3GPP TSG CN Plenary Meeting #12, Stockholm, Sweden 13th - 15th June 2001

Title: CRs to R98 and R99 (with mirror CRs) on Work Item TEI towards 04.08, 24.008

and 23.122,- pack 1

Document for: APPROVAL

Figure 3: Location Registration Task State diagram

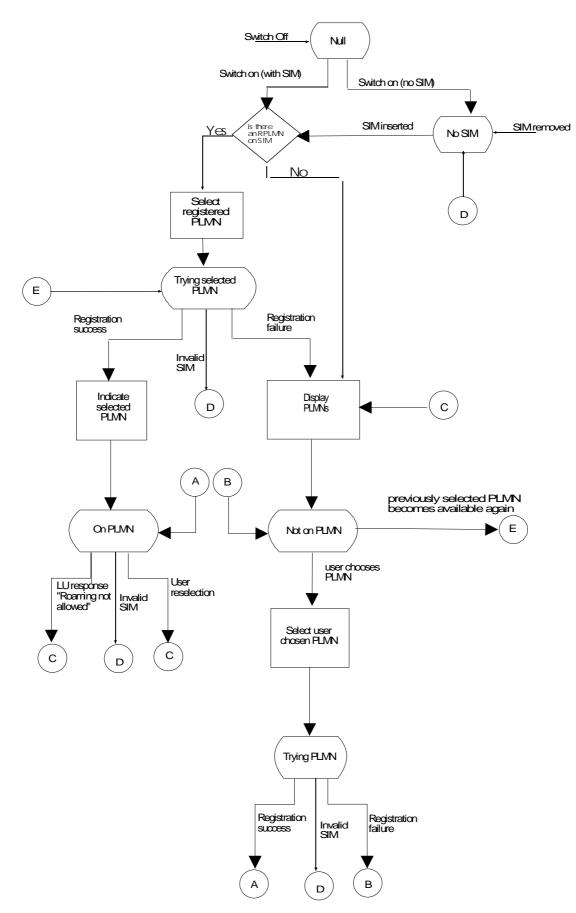
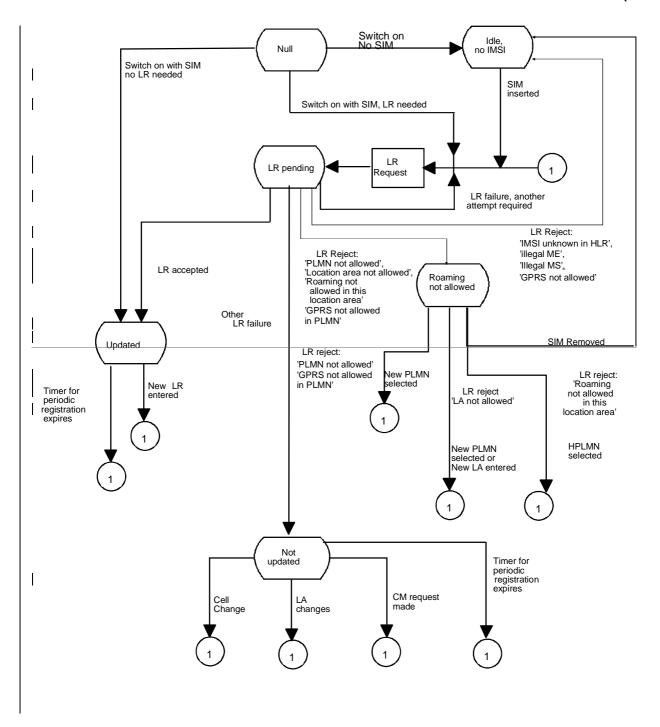
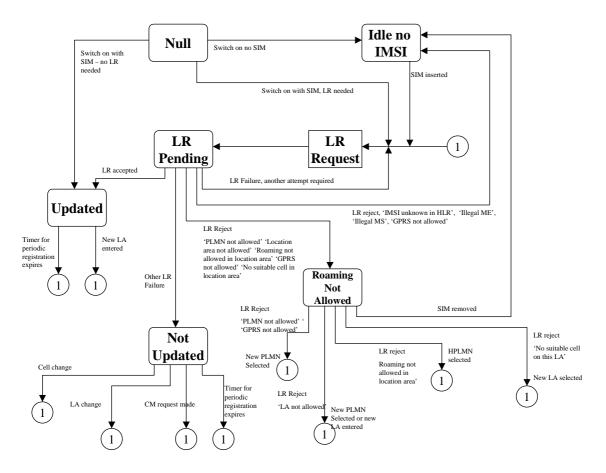
Added change to section 3 figure.

If during location registration the LR response "No Suitable Cells In Location Area" is received:

The MS shall attempt to find another LA of -the same PLMN on which it received the LR response. If the MS is able to find another LA it- shall attempt registration. If the MS is unable to find an LA the PLMN Automatic or Manual Mode Selection Procedure of clause 4.4.3.1--shall be followed, depending on whether the MS is in automatic or manual mode.

Figure 3: Location Registration Task State diagram

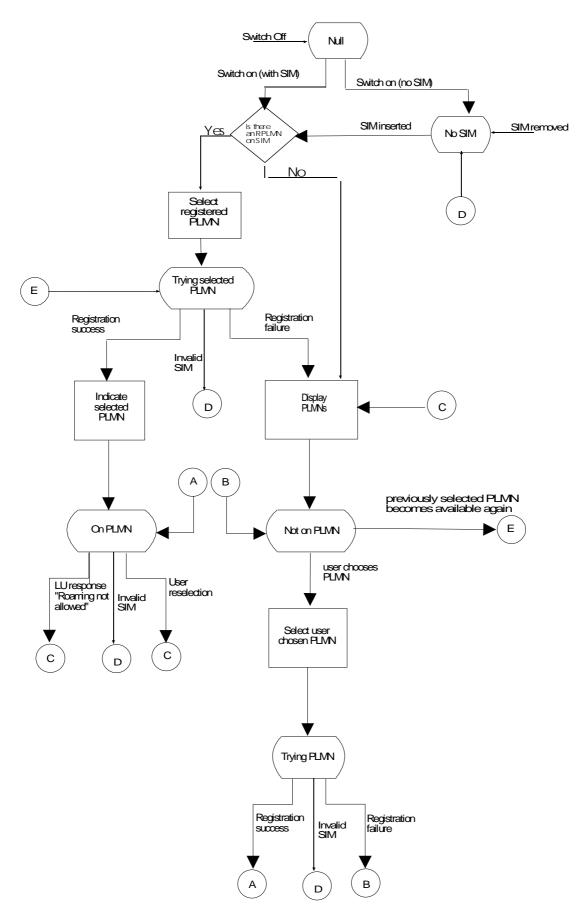
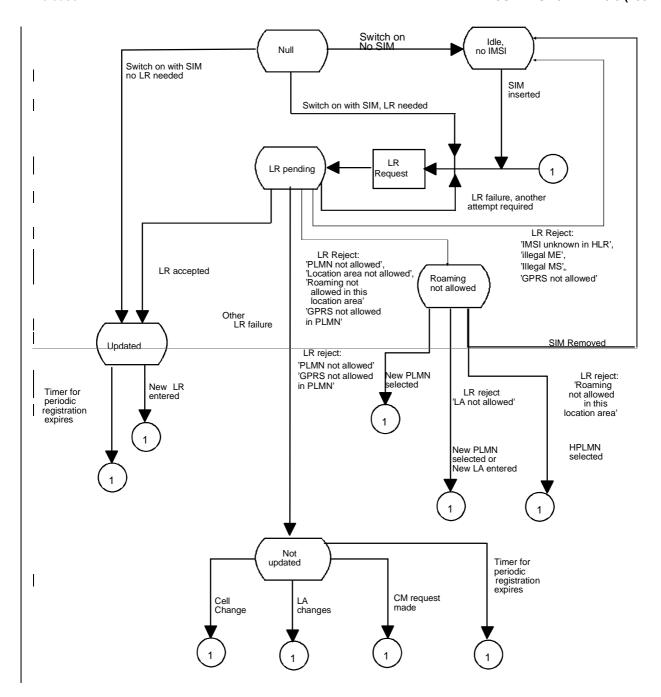
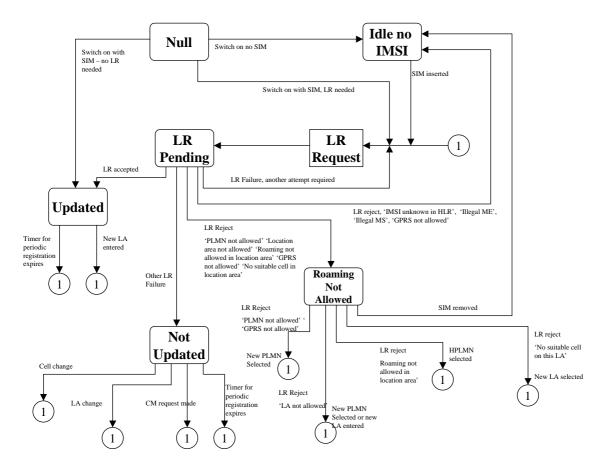
Added change to section 3 figure.

If during location registration the LR response "No Suitable Cells In Location Area" is received:

The MS shall attempt to find another LA of the same PLMN on which it received the LR response. If the MS is able to find another LA it shall attempt registration. If the MS is unable to find an LA the PLMN Automatic or Manual Mode Selection Procedure of clause 4.4.3.1 shall be followed, depending on whether the MS is in automatic or manual mode.
